**SETTLEMENT
AGREEMENT
EXHIBIT D PART 4**

Project:
LEVI STADIUM ACCESSIBILITY

Sheet Description:
700 LEVEL ACCESSIBLE ROUTE OF TRAVEL AND ACCESSIBLE SIGNAGE

800 LEVEL
ACCESSIBLE ROUTE
OF TRAVEL AND
ACCESSIBLE SIGNAGE

Job No.: 19-008 Scale: AS SHOWN
Dwg File Name: Exhibit-D-7.dwg
Sheet: **EXHIBIT D-7**

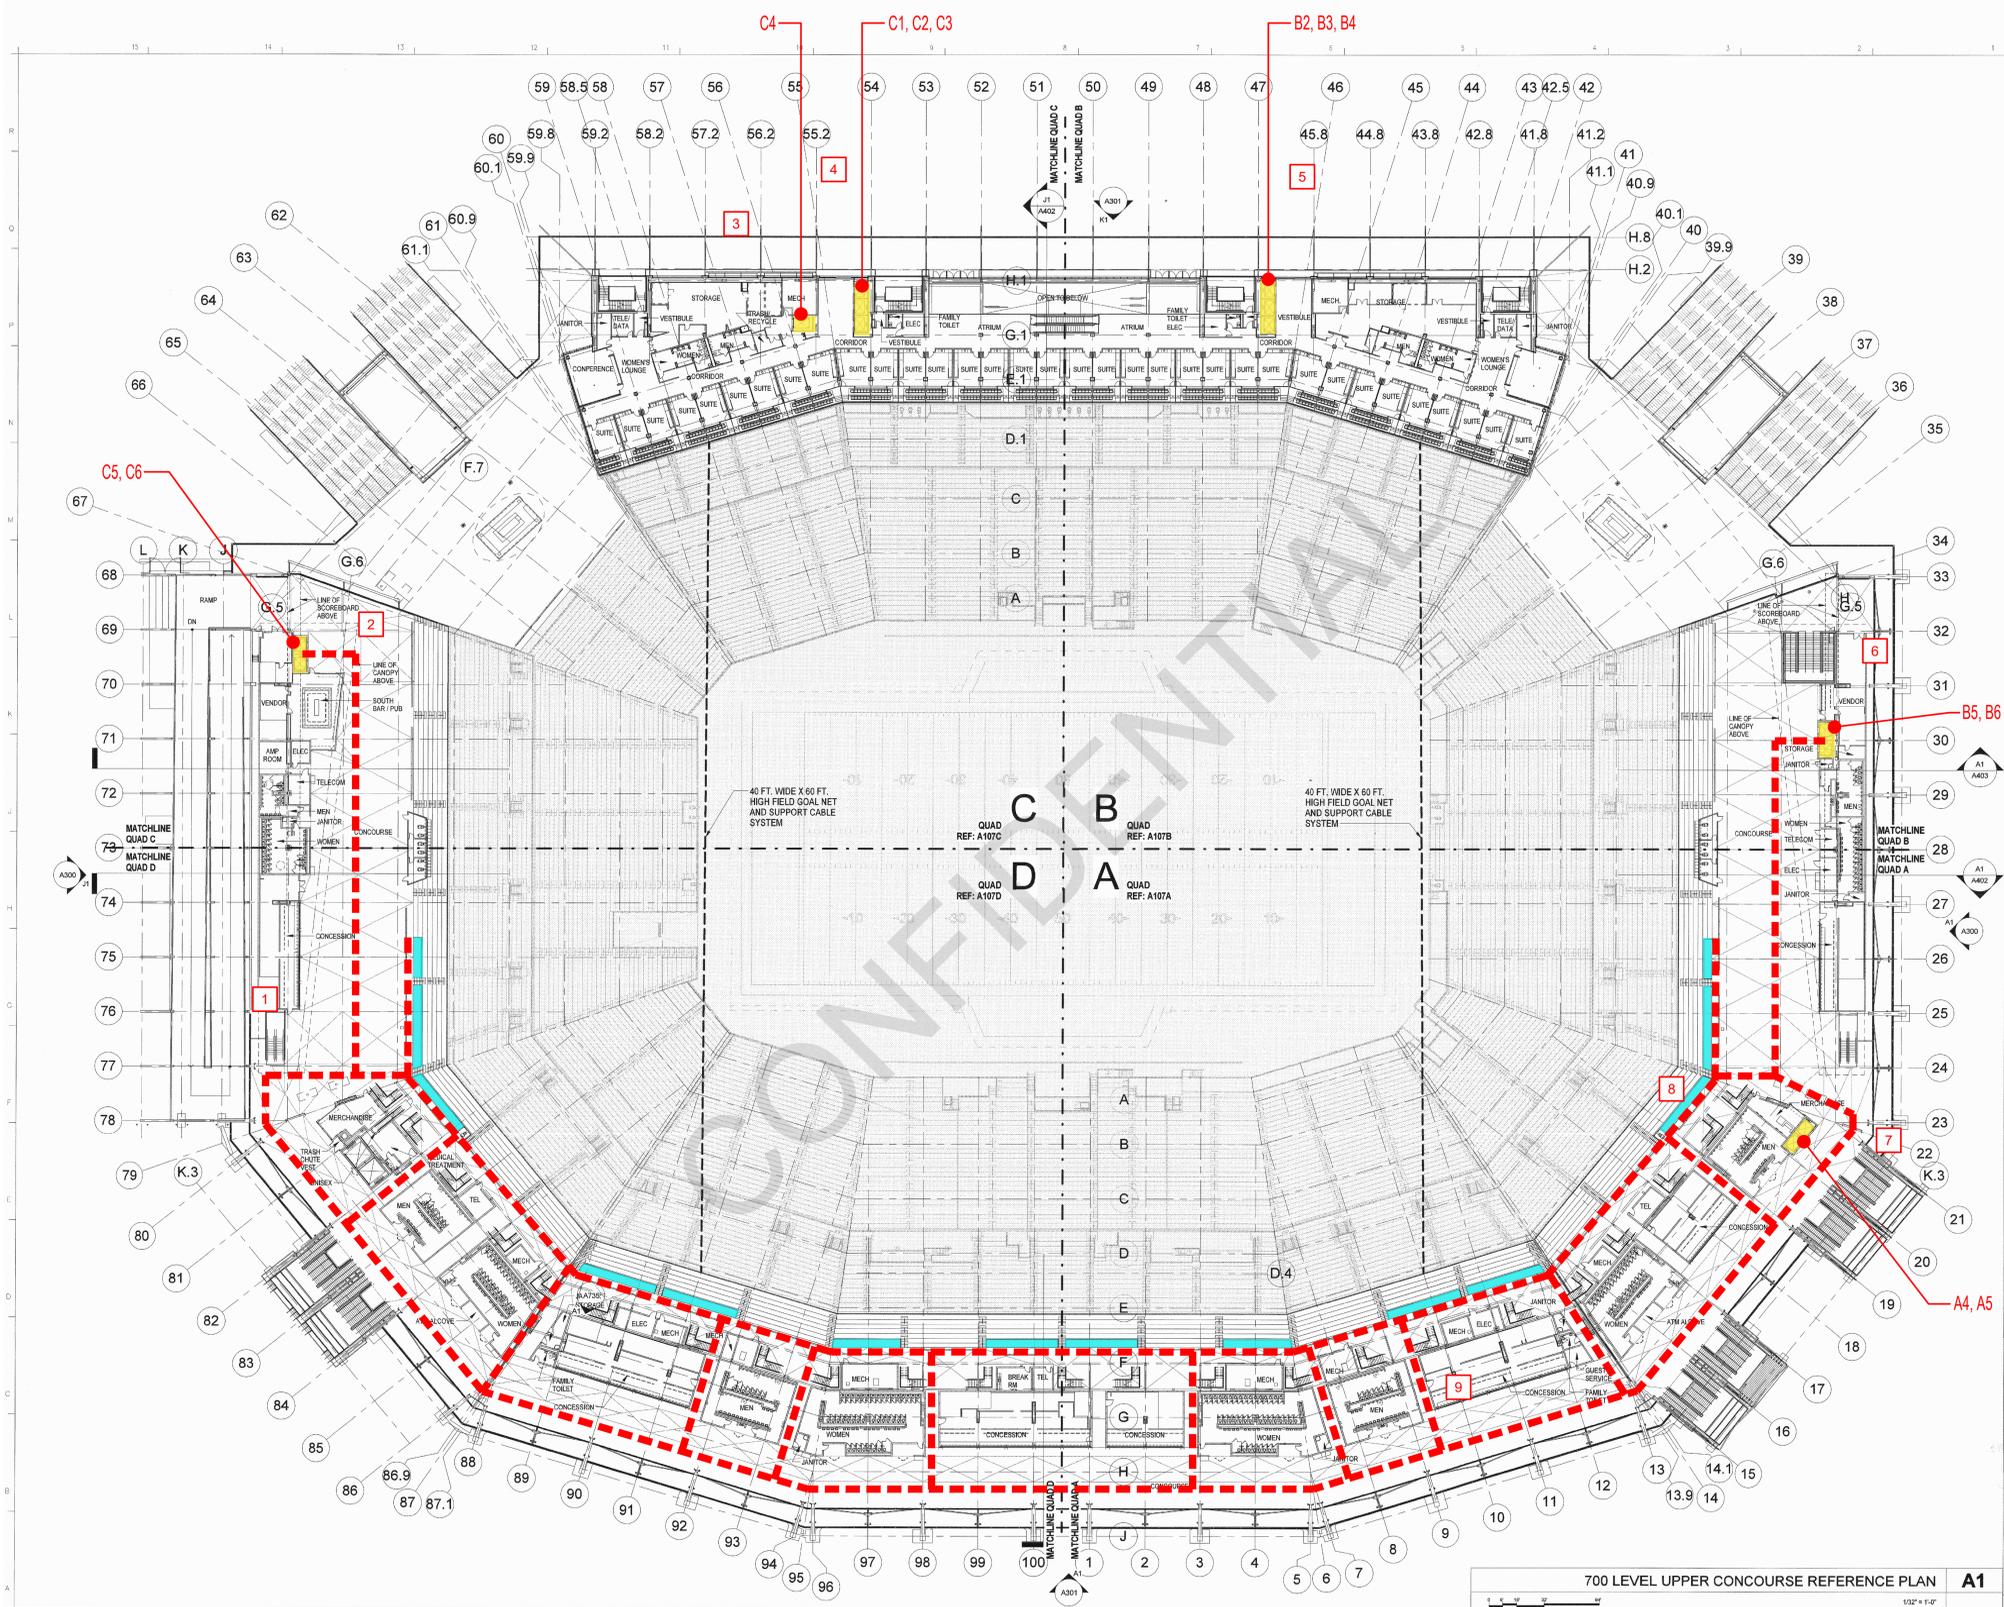
- 1 AT A LOCATION CLEARLY VISIBLE TO PERSONS WITH DISABILITIES AND PROXIMATE TO THE ENTRY TO THE ESCALATOR PROVIDE SIGNAGE INDICATING THE LOCATION OF OF ELEVATORS C5 & C6.

- 2 AT A LOCATION CLEARLY VISIBLE TO PERSONS WITH DISABILITIES WHO USE A WHEELCHAIR AND APPROACHING FROM THE ESCALATORS TO THE EAST PROVIDE SIGNAGE INDICATING THE LOCATION OF OF ELEVATORS C5 & C6.

- 3 AT THE APPROACH TO ELEVATORS C1, C2 & C3 PROVIDE SIGNAGE AT A LOCATION CLEARLY VISIBLE TO PERSONS WITH DISABILITIES USING A WHEELCHAIR THE LOCATION OF ELEVATOR C4 AND INDICATE IT SERVES THE NRG TERRACE. ALSO PROVIDE SIMILAR SIGNAGE AT THE DOORS LEADING TO THE LOBBY AT ELEVATOR C4.

- 4 AT ELEVATORS C1, C2 & C3 PROVIDE SIGNAGE AT A LOCATION CLEARLY VISIBLE TO PERSONS WITH DISABILITIES USING A WHEELCHAIR AND INDICATING THE STADIUM LEVELS THEY SERVE.

- 5 AT ELEVATORS B2, B3 & B4 PROVIDE SIGNAGE AT A LOCATION CLEARLY VISIBLE TO PERSONS WITH DISABILITIES USING A WHEELCHAIR AND INDICATING THE STADIUM LEVELS THEY SERVE. SIGNAGE SHALL ALSO INDICATE THE ELEVATOR B2 SERVES THE NRG TERRACE.

- 6 AT ELEVATORS B5 & B6, PROVIDE SIGNAGE AT A LOCATION CLEARLY VISIBLE TO PERSONS WITH DISABILITIES USING A WHEELCHAIR AND INDICATING THE STADIUM LEVELS THEY SERVE.

- 7 AT ELEVATORS A4 & A5, PROVIDE SIGNAGE AT A LOCATION CLEARLY VISIBLE TO PERSONS WITH DISABILITIES USING A WHEELCHAIR AND INDICATING THE STADIUM LEVELS THEY SERVE.

- 8 AT EACH CONNECTION BETWEEN THE INTERIOR CIRCULATION AND THE OUTER CIRCULATION PROVIDE SIGNAGE AT A LOCATION CLEARLY VISIBLE BY PERSONS WITH DISABILITIES USING A WHEELCHAIR INDICATING THE LOCATION OF THE NEAREST ELEVATORS.

- 9 AT EACH CONNECTION TO THE OUTER CIRCULATION PROVIDE SIGNAGE AT A LOCATION CLEARLY VISIBLE BY PERSONS WITH DISABILITIES USING A WHEELCHAIR INDICATING THE LOCATION OF THE NEAREST ELEVATORS.

Sheet:

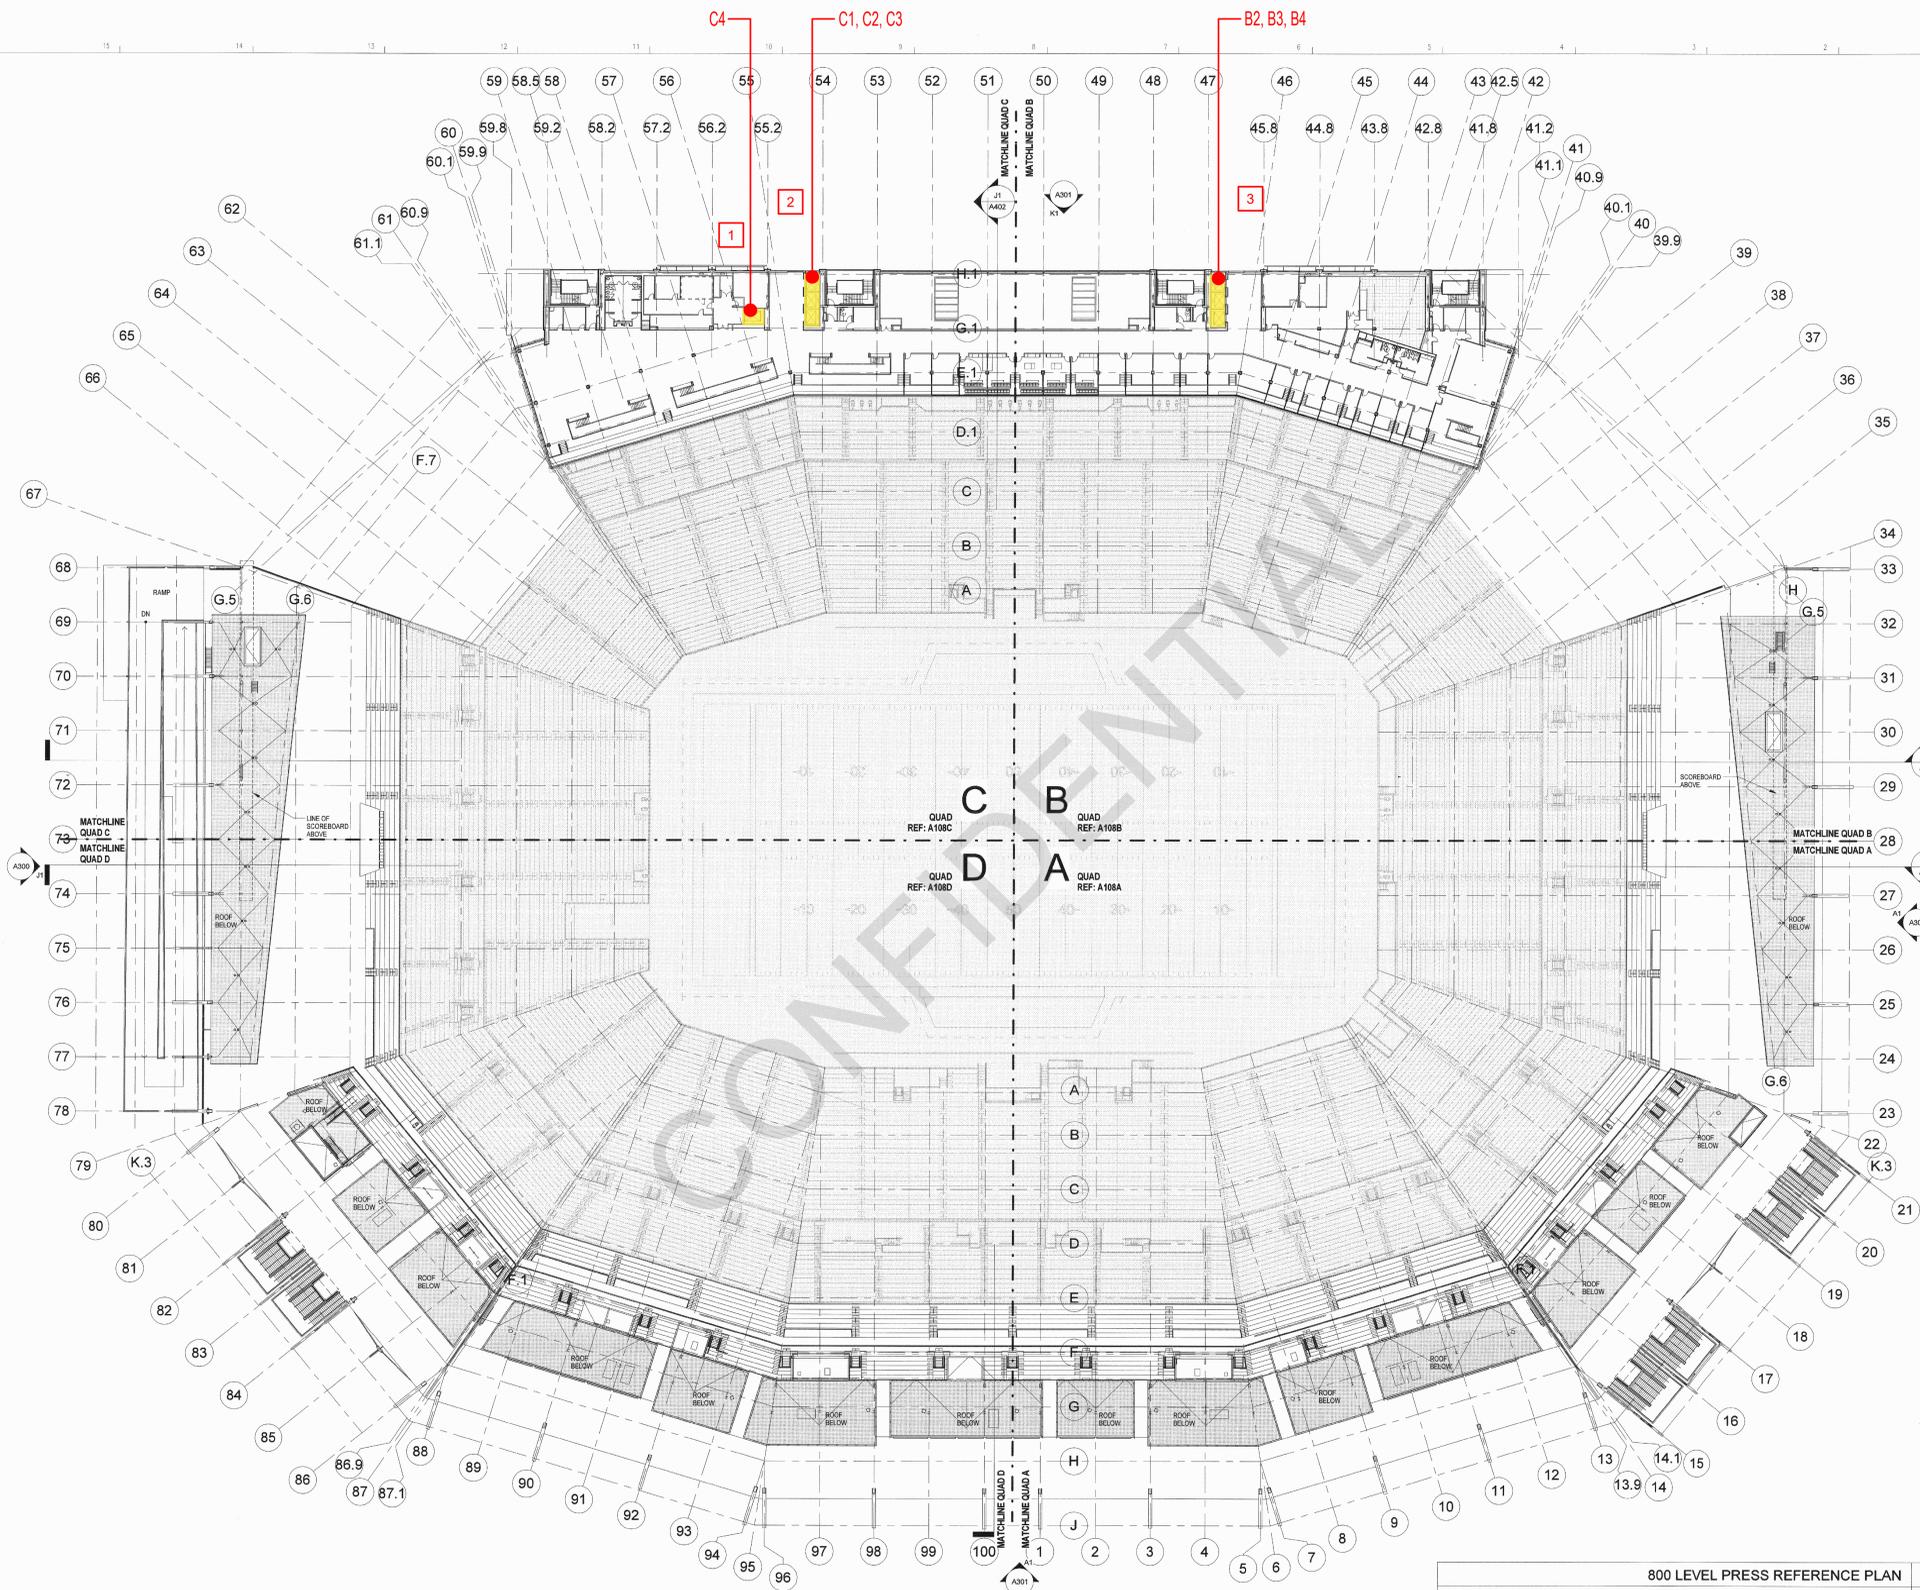
- 1 AT THE APPROACH TO ELEVATORS C1, C2, & C3 PROVIDE SIGNAGE AT A LOCATION CLEARLY VISIBLE TO PERSONS WITH DISABILITIES USING A WHEELCHAIR. THE LOCATION OF ELEVATOR C4 AND INDICATE IT SERVES THE NRG TERRACE. ALSO PROVIDE SIMILAR SIGNAGE AT THE DOOR LEADING TO THE LOBBY OF ELEVATOR C4.
- 2 AT ELEVATORS C1, C2 & C3 PROVIDE SIGNAGE AT A LOCATION CLEARLY VISIBLE TO PERSONS WITH DISABILITIES USING A WHEELCHAIR AND INDICATING THE STADIUM LEVELS THEY SERVE.
- 3 AT ELEVATORS B2, B3 & B4 PROVIDE SIGNAGE AT A LOCATION CLEARLY VISIBLE TO PERSONS WITH DISABILITIES USING A WHEELCHAIR AND INDICATING THE STADIUM LEVELS THEY SERVE. SIGNAGE SHALL ALSO INDICATE THE ELEVATOR B2 SERVES THE NRG TERRACE.
